EPSC PLAN NARRATIVE

SHEET NAME: EPSC NARRATIVE BRIDGE 52
PROJECT NAME: WINHALL
PROJECT NO: STP CULV (31)
SHEET NO. 1 OF 8
DRAWN BY: CE
CHK'D BY:
DATE: 04/16/2015

From: Jacqueline Dagesse [mailto:jdagesse@eivtech.com]
Sent: Wednesday, April 29, 2015 7:16 PM
To: Lemaire, Ron
Cc: Farley, William; Mackintosh, Mark
Subject: Winhall STP CULV(31) EPSC Plan Review

From: McIntosh, Mindon (Buffalo) [mindon.mcintosh@aecom.com]
Sent: Monday-May 11-2015 8-20 AM
To: cezequelle@gmail.com; renaudbr@sover.net
Cc: acentofranchi@eivtech.com; ron.lemaire@state.vt.us
Subject: Winhall STO CULV (31) EPSC Plan

SHEET NAME: BRIDGE 52 EROSION CONTROL PLAN
PROJECT NAME: WINHALL
PROJECT NO: STP CULV (31)
SHEET NO. 2 OF 8
DRAWN BY: CE
CHK'D BY:
DATE: 04/16/2015

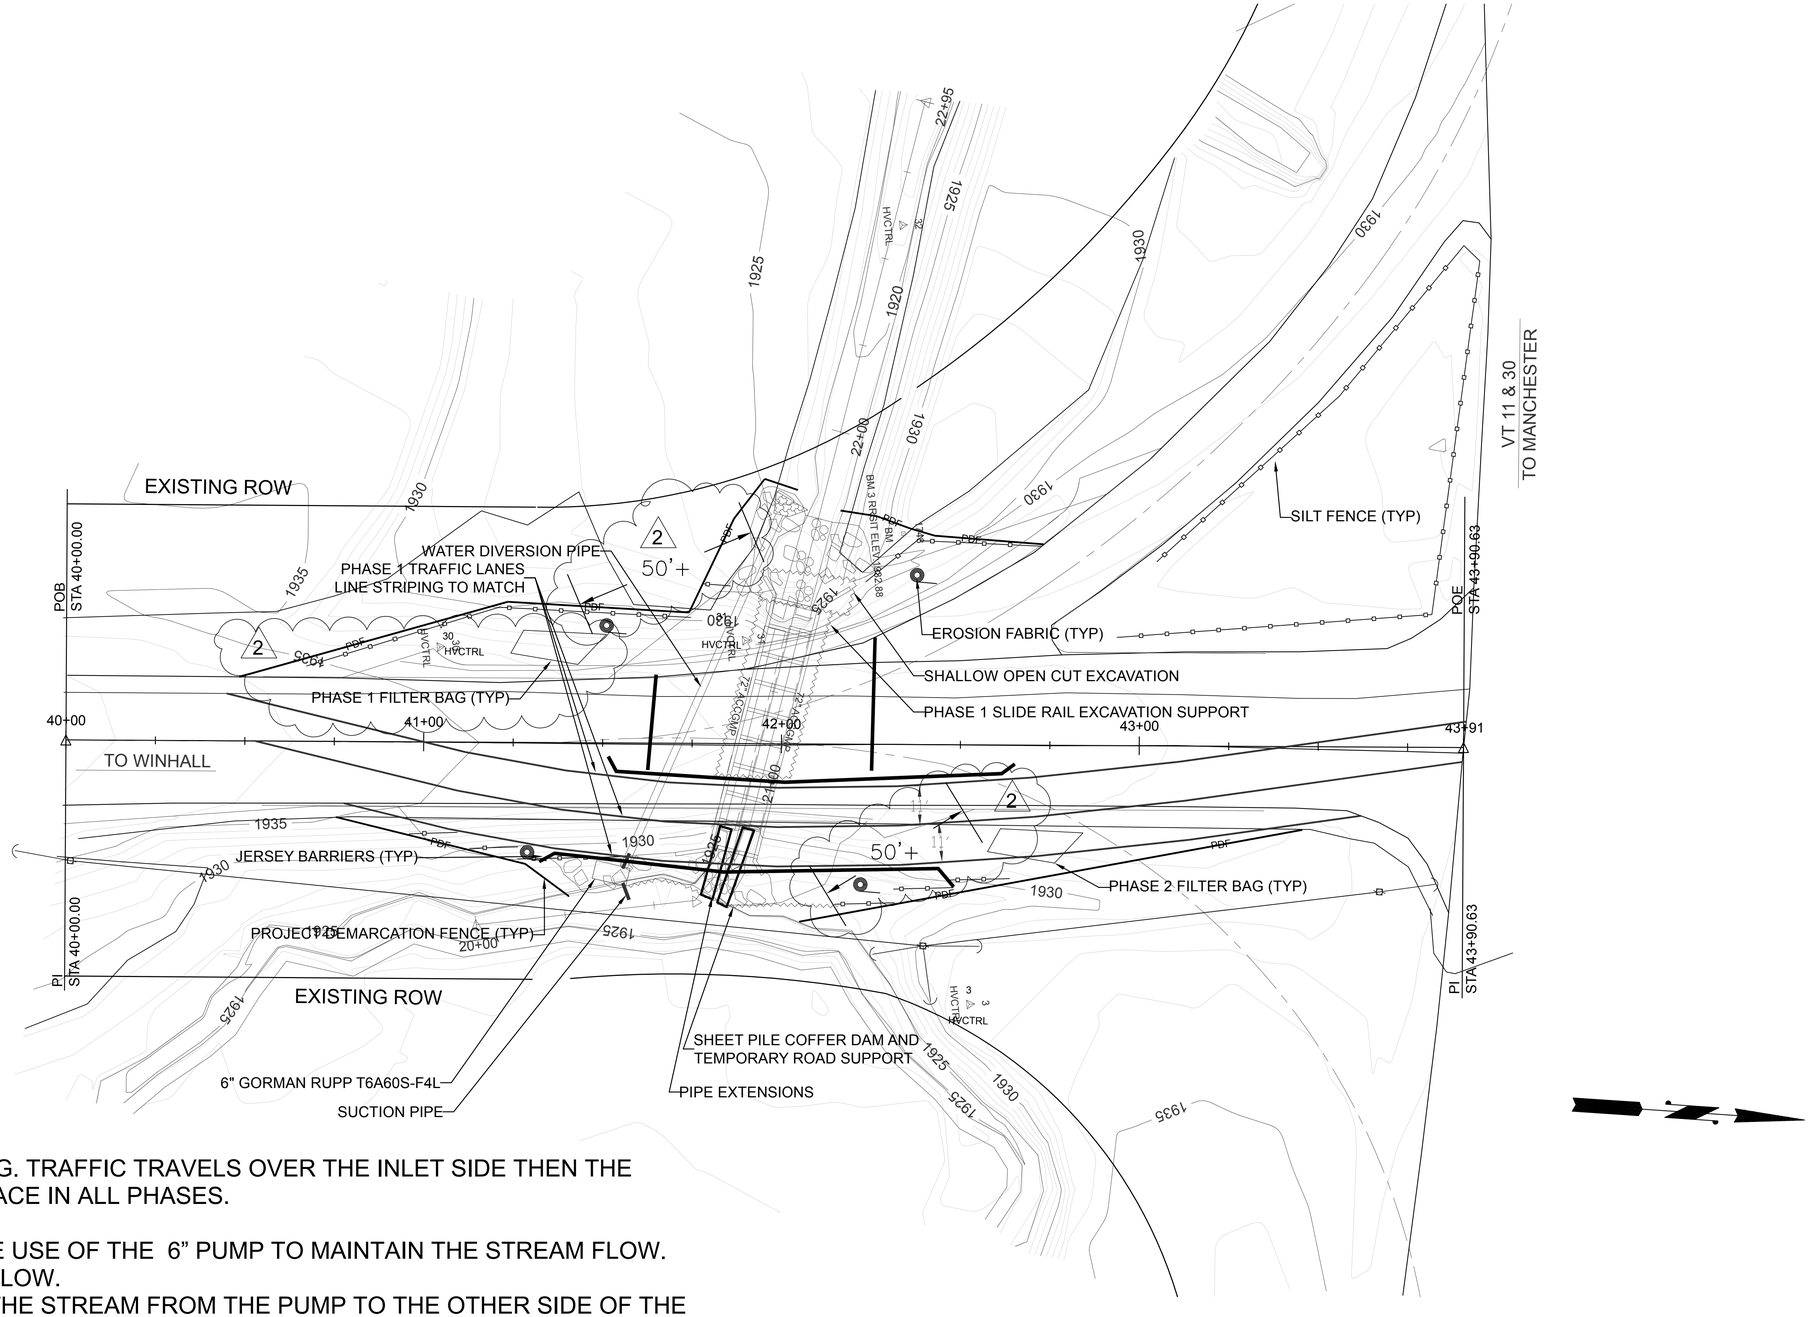
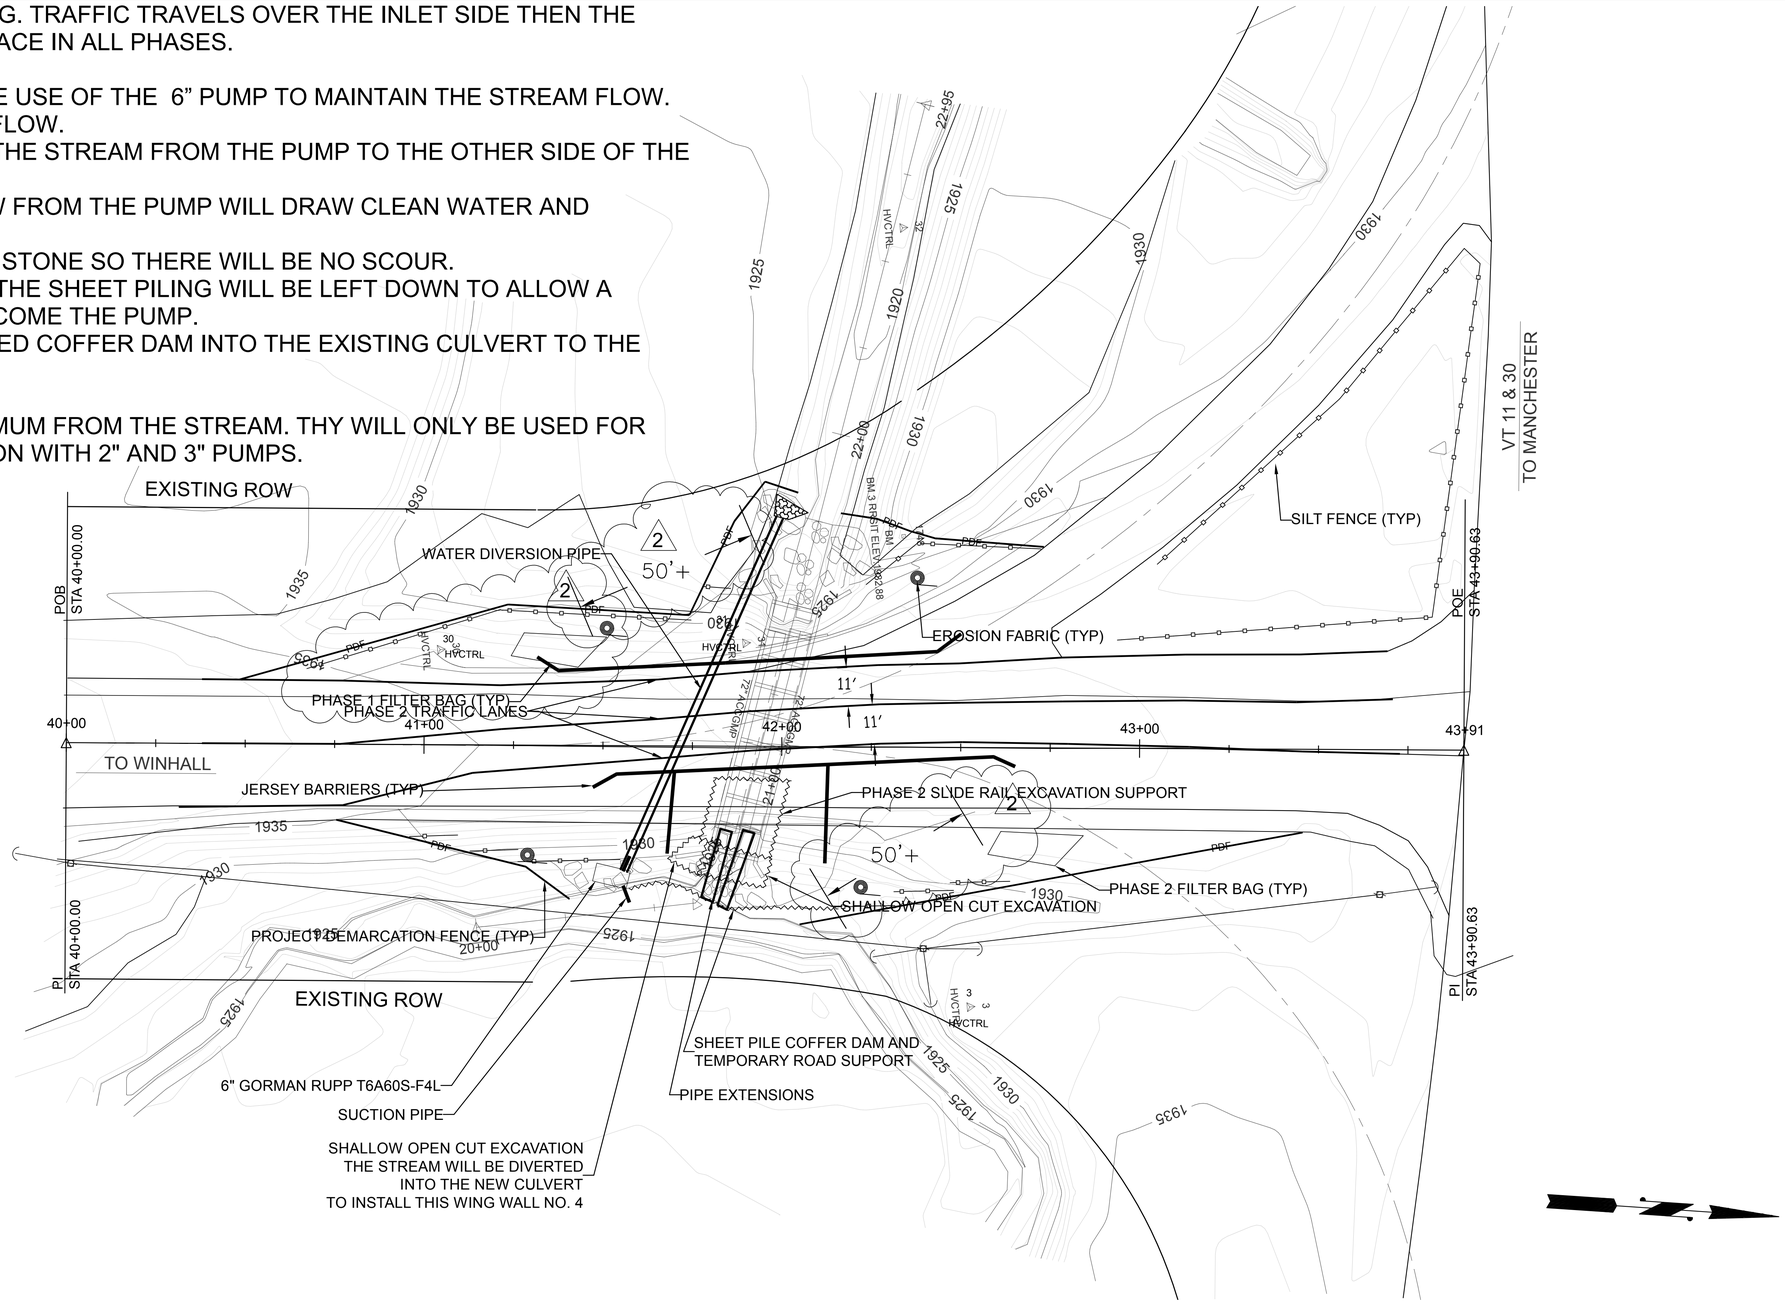
- The plansheets reference 'Phase 1' and 'Phase 2'. What are these phases? There is no description of these phases within the EPSCP narrative. We need additional detail on what they plan to do.
- On sheet 6 of 7 they reference a 6" pump. What is this used for and where is it pumping to? What are the calculations for this sizing?
- Can they confirm if the Phase 1 filter bag is 50' away from the river?

Pease reference these on the EPSC plan.
Show approx. location of silt bag.

SEE TRAFFIC CONTROL PLANS FOR PHASING. TRAFFIC TRAVELS OVER THE INLET SIDE THEN THE OUTLET SIDE. ALL EPSC ITEM REMAIN IN PLACE IN ALL PHASES.

SEE THE STREAM DIVERSION PLAN FOR THE USE OF THE 6" PUMP TO MAINTAIN THE STREAM FLOW.
THE 6" PUMP WILL HANDLE THE 25cfs OHW FLOW.
THE PIPE LAID ACROSS THE ROAD CARIES THE STREAM FROM THE PUMP TO THE OTHER SIDE OF THE ROAD.
BY BUILDING AN ADAQUATE POND TO DRAW FROM THE PUMP WILL DRAW CLEAN WATER AND DISCHARGE CLEAN WATER.
THE CLEAN WATER WILL DISCHARGE ONTO STONE SO THERE WILL BE NO SCOUR.
AT THE INLET OF THE EXISTING CULVERTS THE SHEET PILING WILL BE LEFT DOWN TO ALLOW A RELIEF FOR THE STREAM SHOULD IT OVERCOME THE PUMP.
THE STREAM WILL FLOW OVER THE LOWERED COFFER DAM INTO THE EXISTING CULVERT TO THE NEW CULVERT AND BACK TO THE STREAM.

THE FILTER BAGS WILL BE PLACED 50' MINIMUM FROM THE STREAM. THY WILL ONLY BE USED FOR LOCALIZED PUMPING FROM THE EXCAVATION WITH 2" AND 3" PUMPS.

SEE TRAFFIC CONTROL PLANS FOR PHASING. TRAFFIC TRAVELS OVER THE INLET SIDE THEN THE OUTLET SIDE. ALL EPSC ITEM REMAIN IN PLACE IN ALL PHASES.

SEE THE STREAM DIVERSION PLAN FOR THE USE OF THE 6" PUMP TO MAINTAIN THE STREAM FLOW.
THE 6" PUMP WILL HANDLE THE 25cfs OHW FLOW.
THE PIPE LAID ACROSS THE ROAD CARIES THE STREAM FROM THE PUMP TO THE OTHER SIDE OF THE ROAD.
BY BUILDING AN ADAQUATE POND TO DRAW FROM THE PUMP WILL DRAW CLEAN WATER AND DISCHARGE CLEAN WATER.
THE CLEAN WATER WILL DISCHARGE ONTO STONE SO THERE WILL BE NO SCOUR.
AT THE INLET OF THE EXISTING CULVERTS THE SHEET PILING WILL BE LEFT DOWN TO ALLOW A RELIEF FOR THE STREAM SHOULD IT OVERCOME THE PUMP.
THE STREAM WILL FLOW OVER THE LOWERED COFFER DAM INTO THE EXISTING CULVERT TO THE NEW CULVERT AND BACK TO THE STREAM.

THE FILTER BAGS WILL BE PLACED 50' MINIMUM FROM THE STREAM. THY WILL ONLY BE USED FOR LOCALIZED PUMPING FROM THE EXCAVATION WITH 2" AND 3" PUMPS.
